**Duane Arnold Energy Center**

Response to Request for Additional Information Related to the Relief Request for  
Drywell Stabilizer Examinations

**Response to Request for Additional Information (RAI) Related  
to the Relief Request for Drywell Stabilizer Examinations**

COOLER 2A/2B  
RIGGING/MOVING  
PLAN

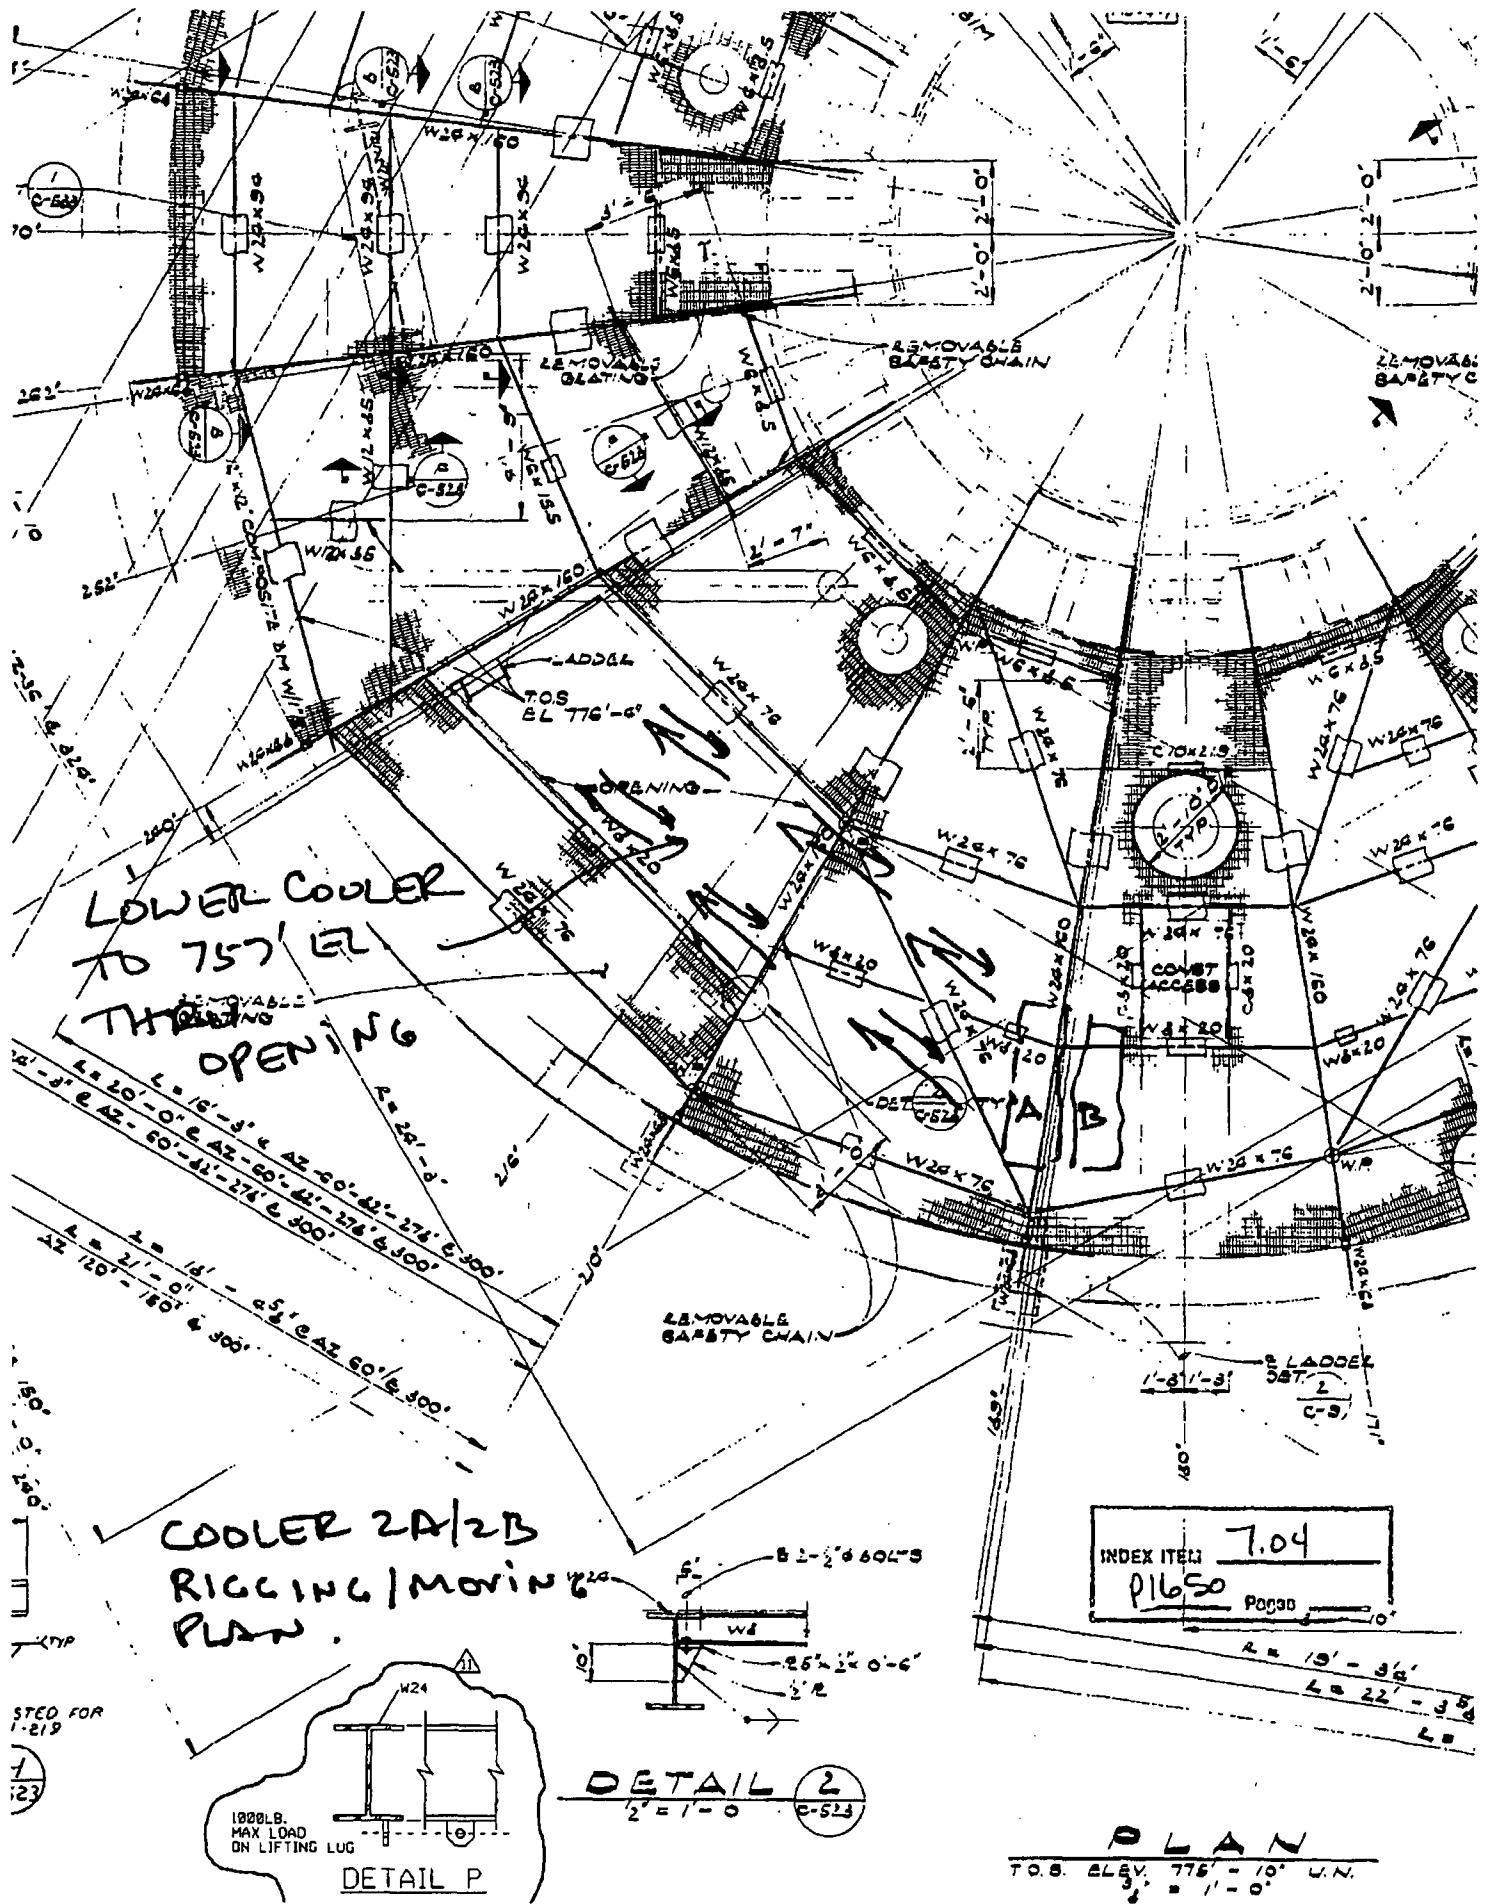
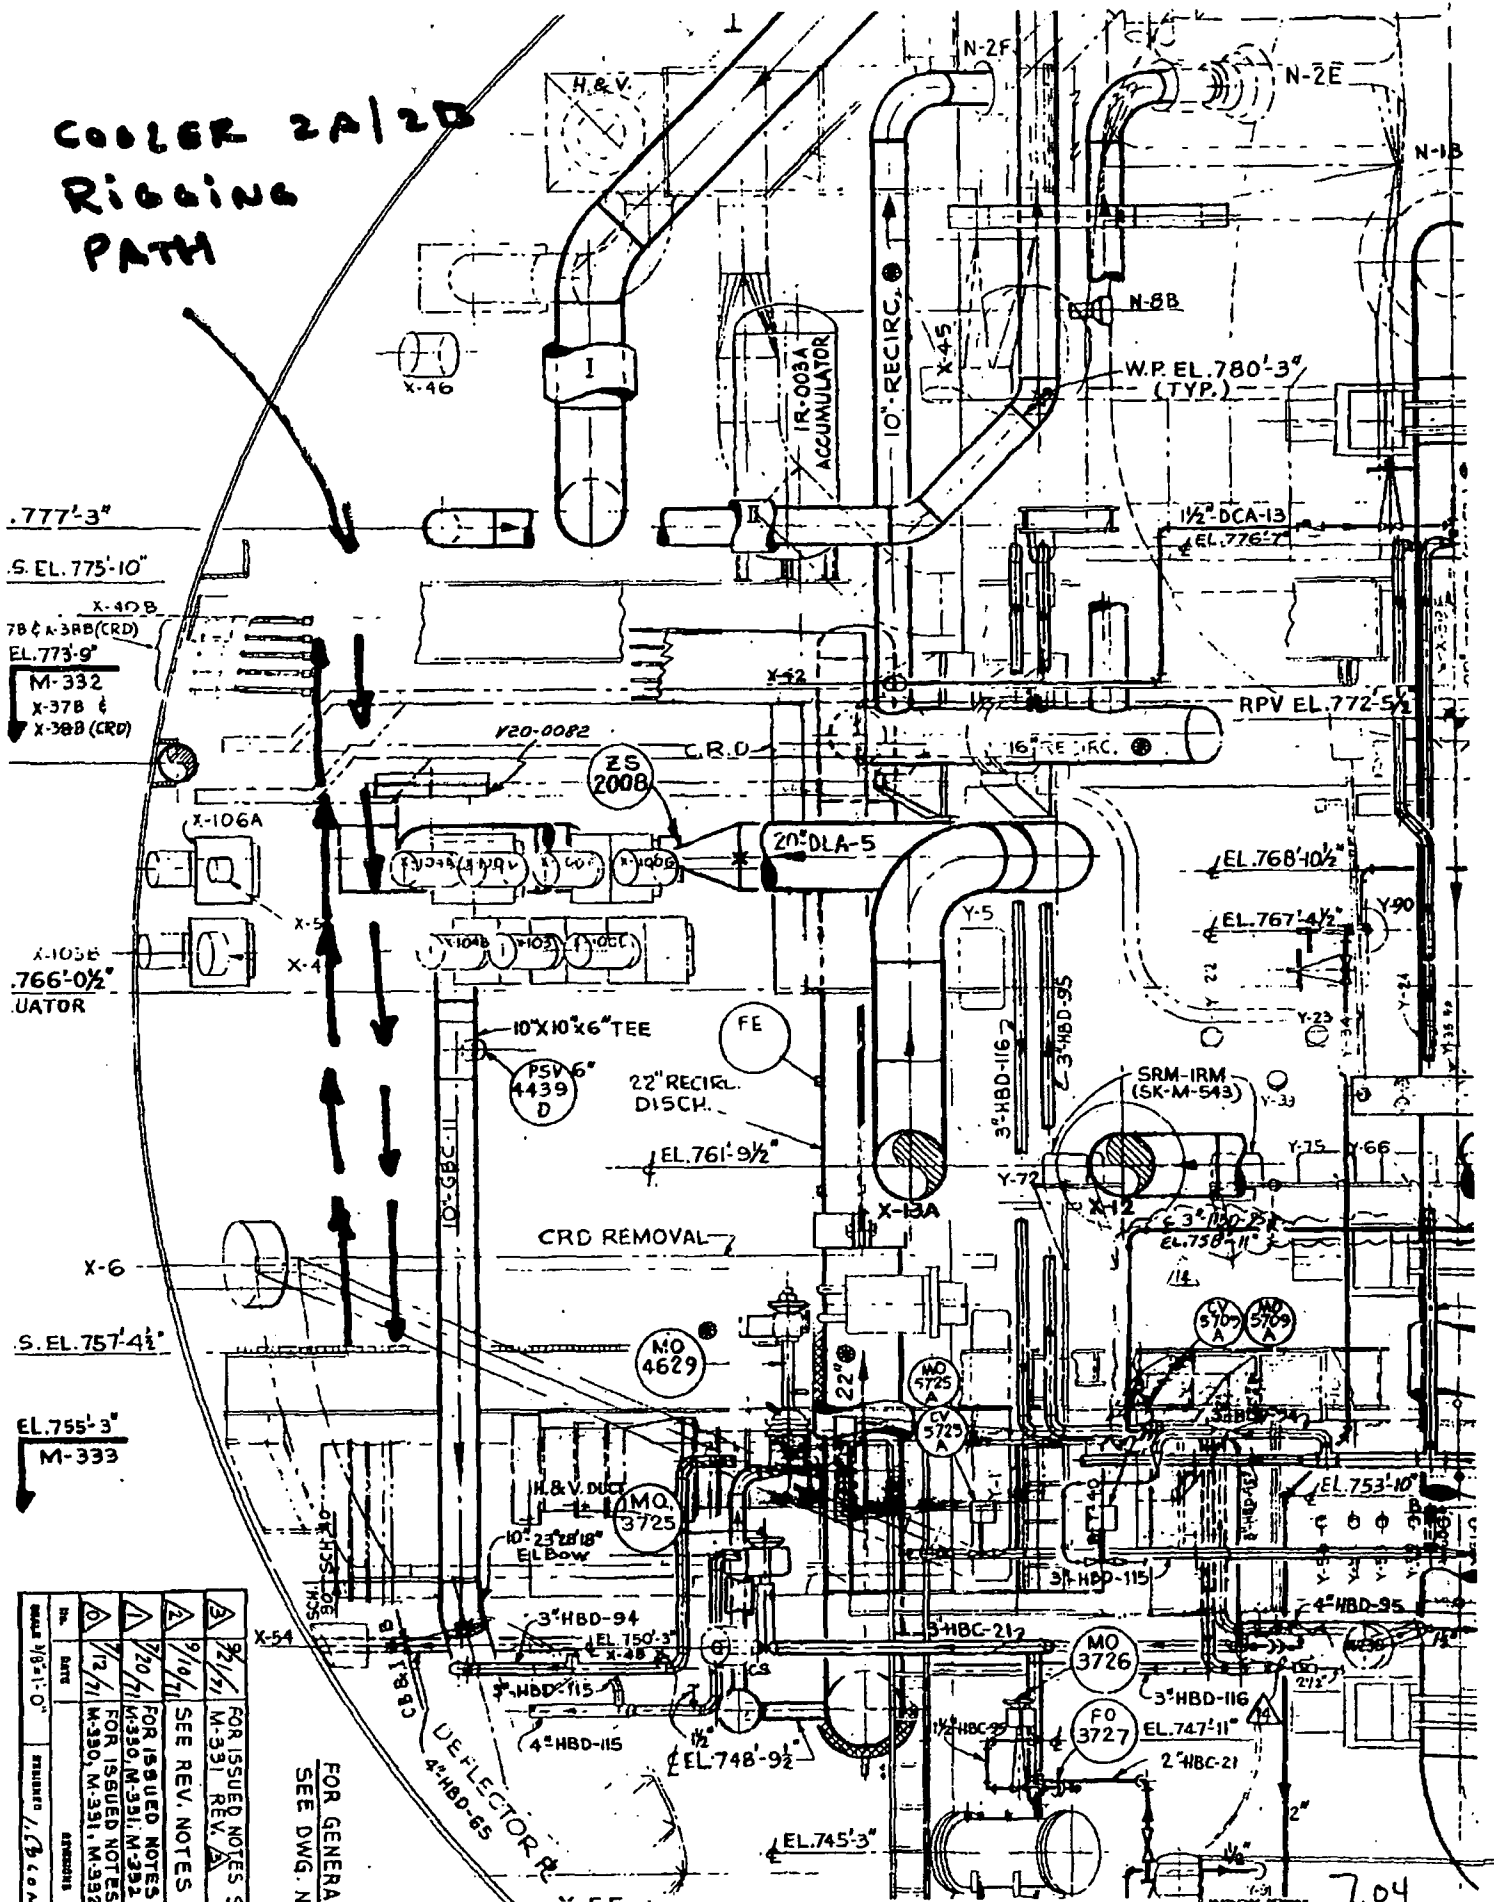
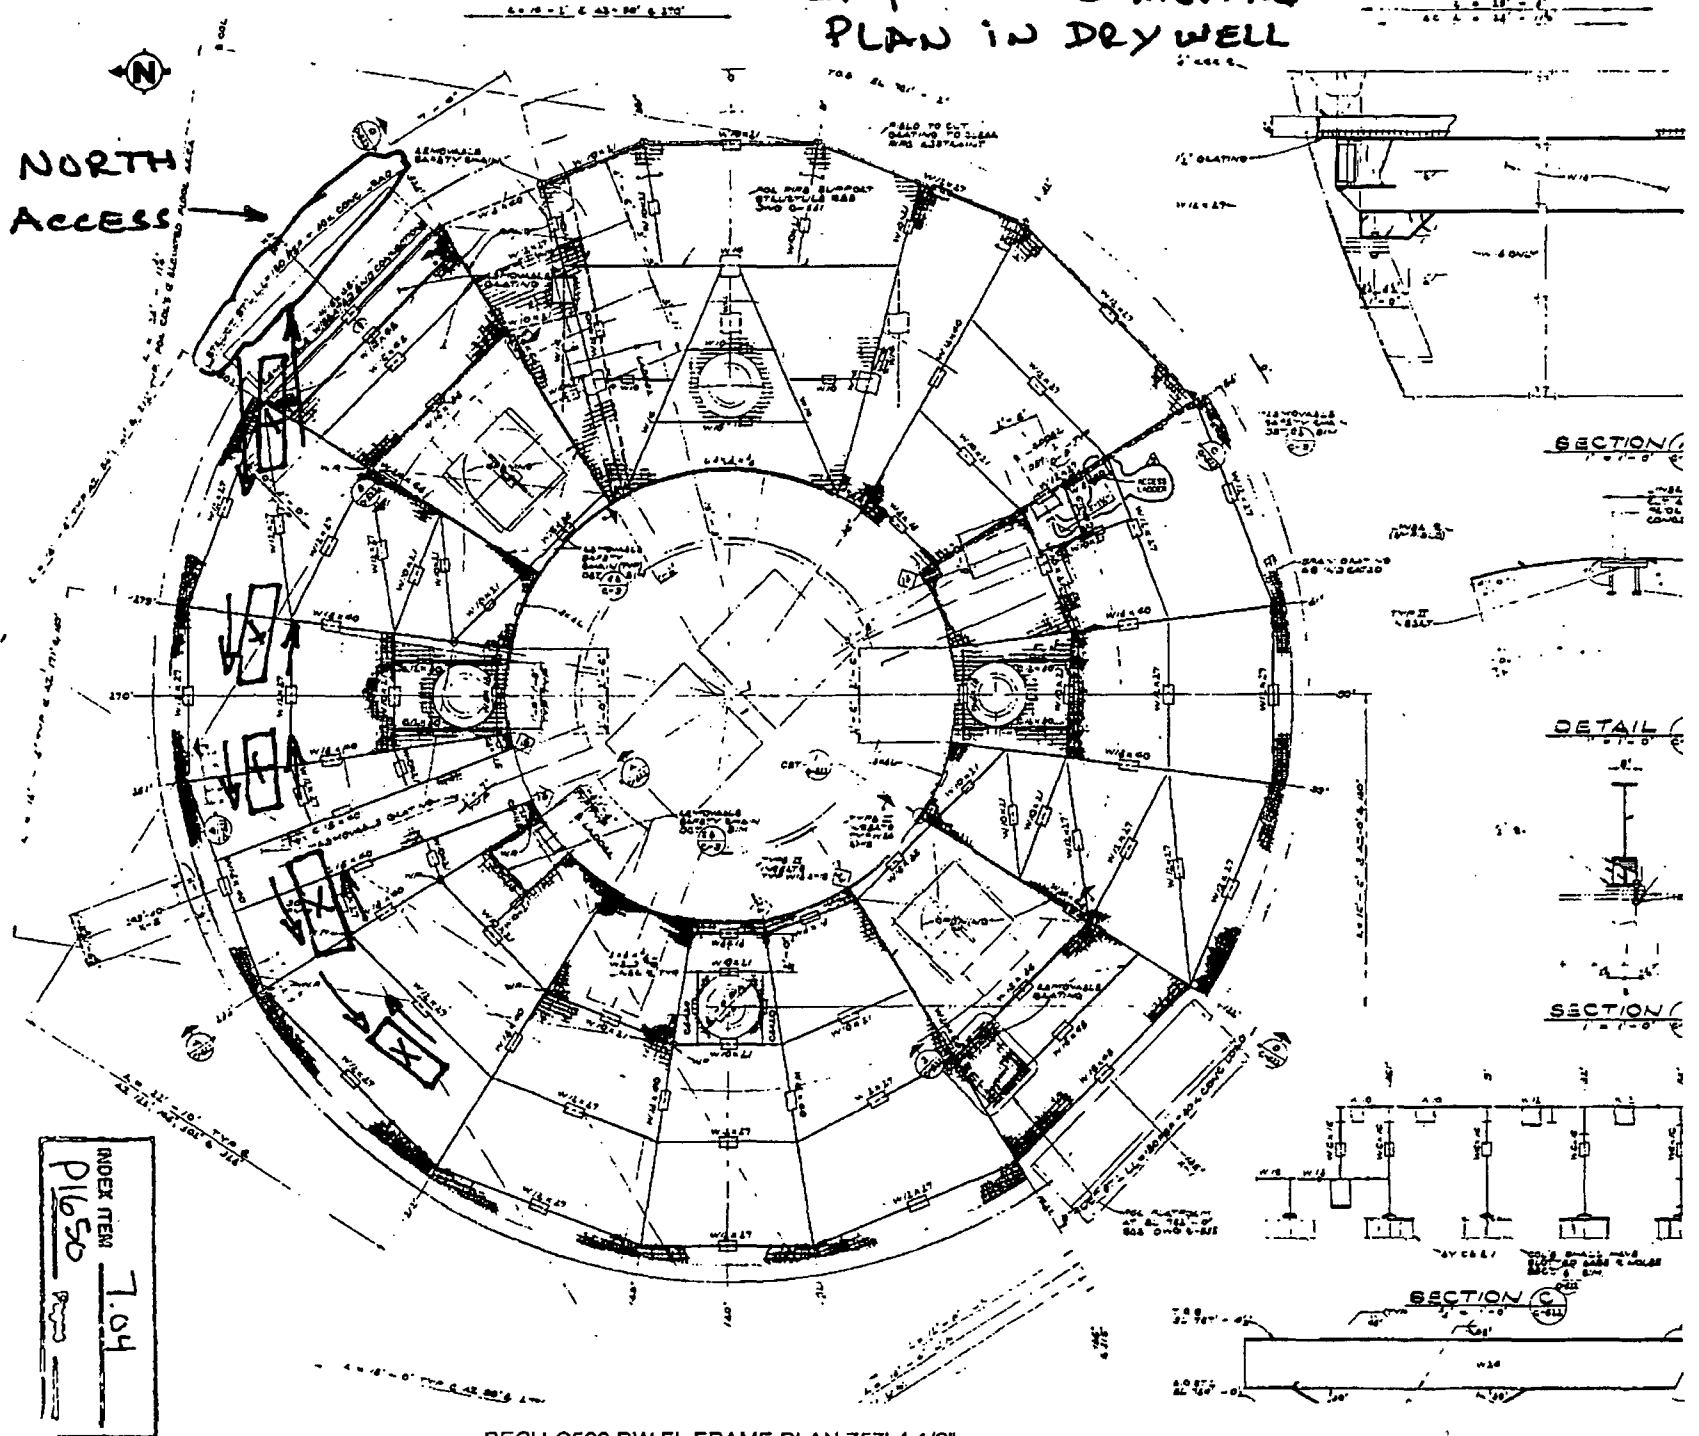
In the last paragraph of the "Reason for Request" section of the Relief Request, the licensee stated that "Examination of the Drywell Stabilizers X-58C and X-58G, which includes ... and a very disproportionate impact on expenditures of plant manpower and radiation exposure." Please provide a quantitative estimate of the effort involved, time duration required, the area dose-rate and the resulting personnel dose that could result from radiation exposure for each of these drywell stabilizers if the VT-3 examinations were to be performed as required by ASME Code, Section XI.

To provide an estimate of the amount of work required to remove the drywell coolers and reinstall them after performing the visual examination, a copy of the "Cooler Moving Plan 1V-CC-2A/2B" from ECP-1650 is attached in Enclosure 3. The weight of each cooler is approximately 2500 pounds. The steps for removing the cooler would consist of removing the structural steel, installing a gantry crane, removal of the necessary fasteners, draining the coolers, prying up the coils for removal, and rigging the coils out of the way. Reinstallation would consist of moving the coils back into position with the gantry crane, reinstallation of the fasteners and reinstalling the structural steel. This is considered to be a significant amount of work to allow access to remove the manhole cover to perform the visual examination of Stabilizers X-58C and X-58G. Based on the amount of work involved as outlined in Enclosure 3, it is clear that the time to prepare for, perform, and restore from the inspections would be significant, on the order of weeks.
